Product Change Notice (PCN)

PCN Number: PCN-0451091R-01

Product(s) Affected: *PJ-043-SMT-TR*

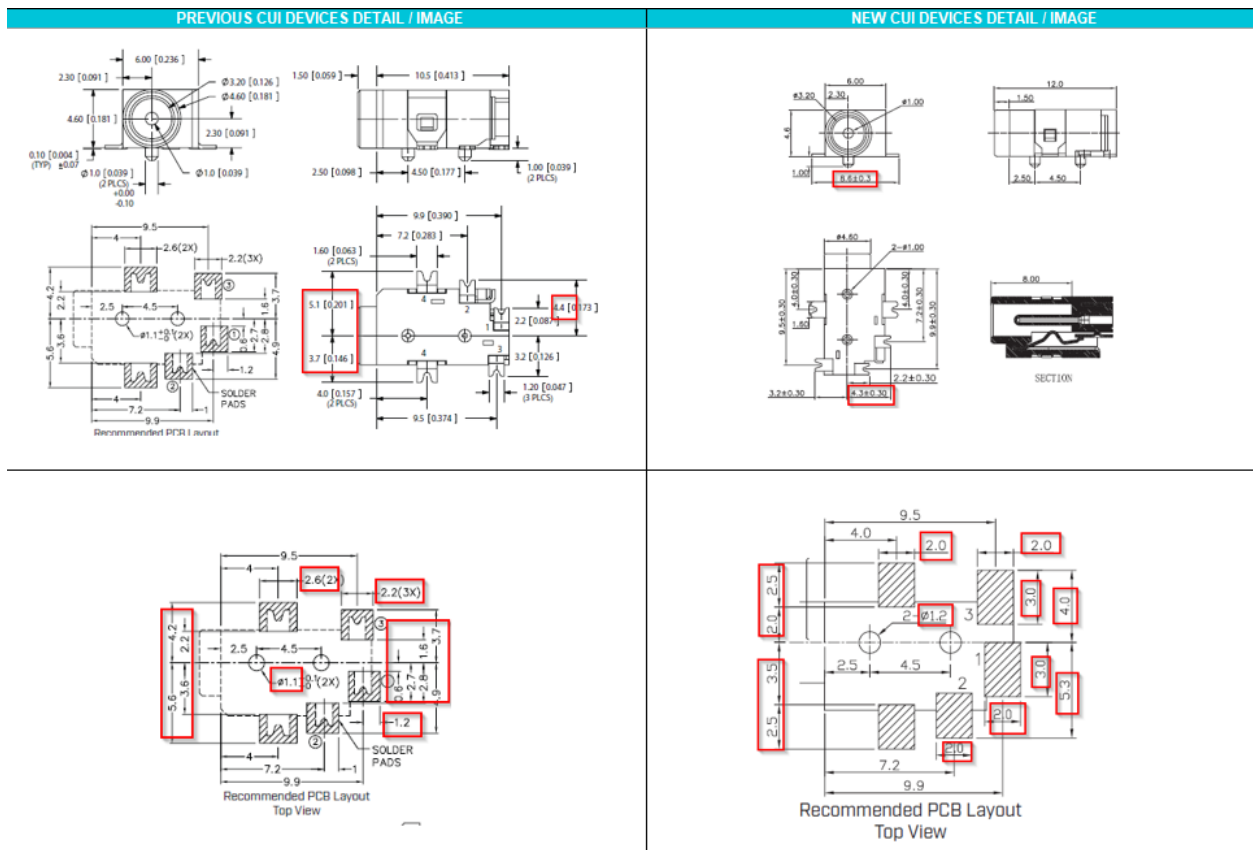
Description of Change: *Minor Housing and footprint differences. Material Change on the housing and terminals. See image Below*

PREVIOUS CUI DEVICES DETAIL / IMAGE			NEW CUI DEVICES DETAIL / IMAGE		
	MATERIAL	PLATING	DESCRIPTION	MATERIAL	PLATING/COLOR
center pin	brass	silver	center pin	brass	tin
terminal 1	brass	silver	terminal 1	brass t-0.25	tin
terminal 2	copper alloy	silver	terminal 2	SUS301 t-0.25	tin
terminal 3	brass	silver	terminal 3	brass t-0.25	tin
shield	cold rolled steel	nickel	shield	brass t-0.25	tin
plastic	PA6T or equivalent		housing	PA9T (UL94V-0)	black
